Groundwater Transfer Review Summary Form

Transfer/PA # T- 13104

Application: T-13104

Applicant Name: Monte Heid

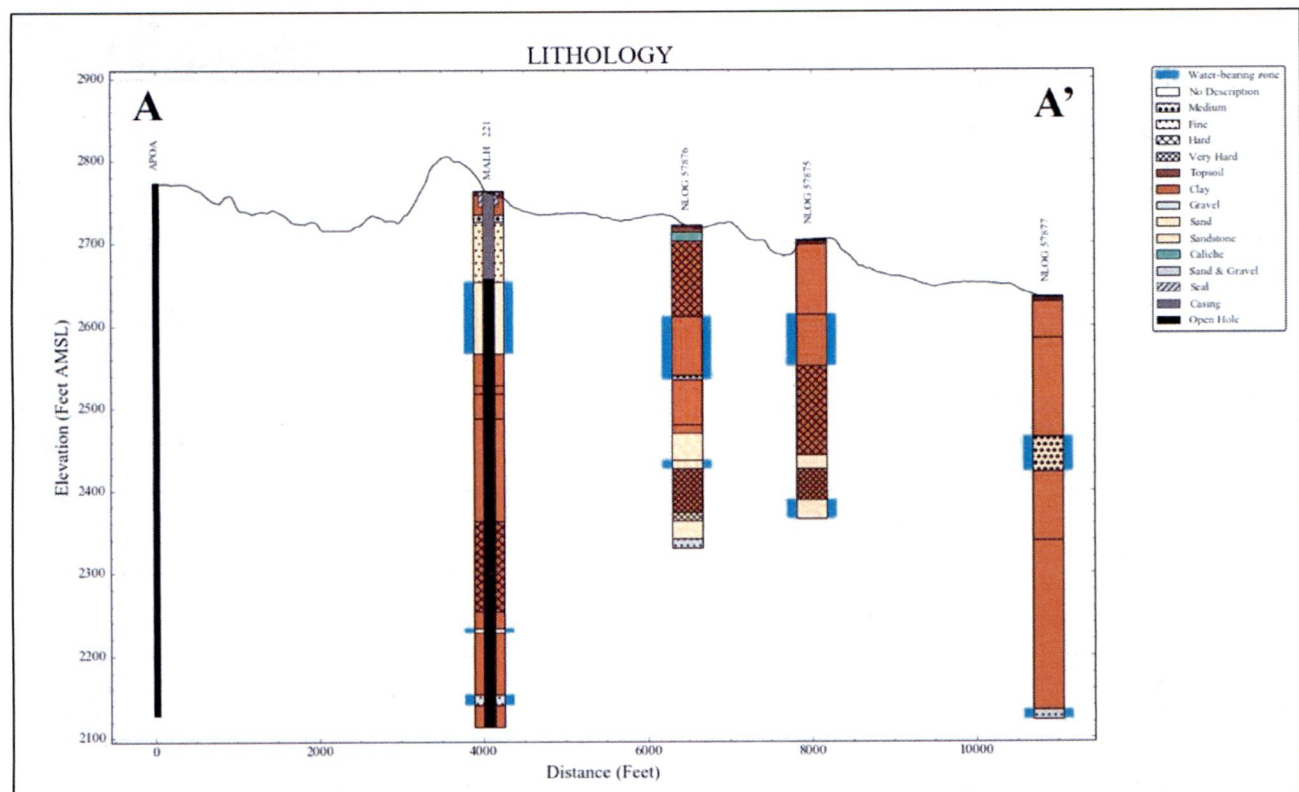
4. a) Will this proposed change, at its maximum allowed rate of use, likely result in an increase in interference with **another ground water right**?
☒ Yes ☐ No Comments: The proposed POA location places it closer to POA well 3 under permit G-13533, owned by Sagebrush Farms, LLC (2,150' versus 3,420' at the closest authorized POA location).

- b) If yes, would this proposed change, at its maximum allowed rate of use, likely result in another groundwater right not receiving the water to which it is legally entitled?
☐ Yes ☒ No If yes, explain: The change in distance to the nearest neighboring POA is not expected to significantly affect groundwater availability at that location.

The applicant's authorized POA wells all produce from alluvium, predominantly from sand and gravel horizons in a thick section of fine-grained clay and tuffaceous siltstone. The proposed APOA well will likely be constructed similarly to MALH 221. See attached map for well locations.
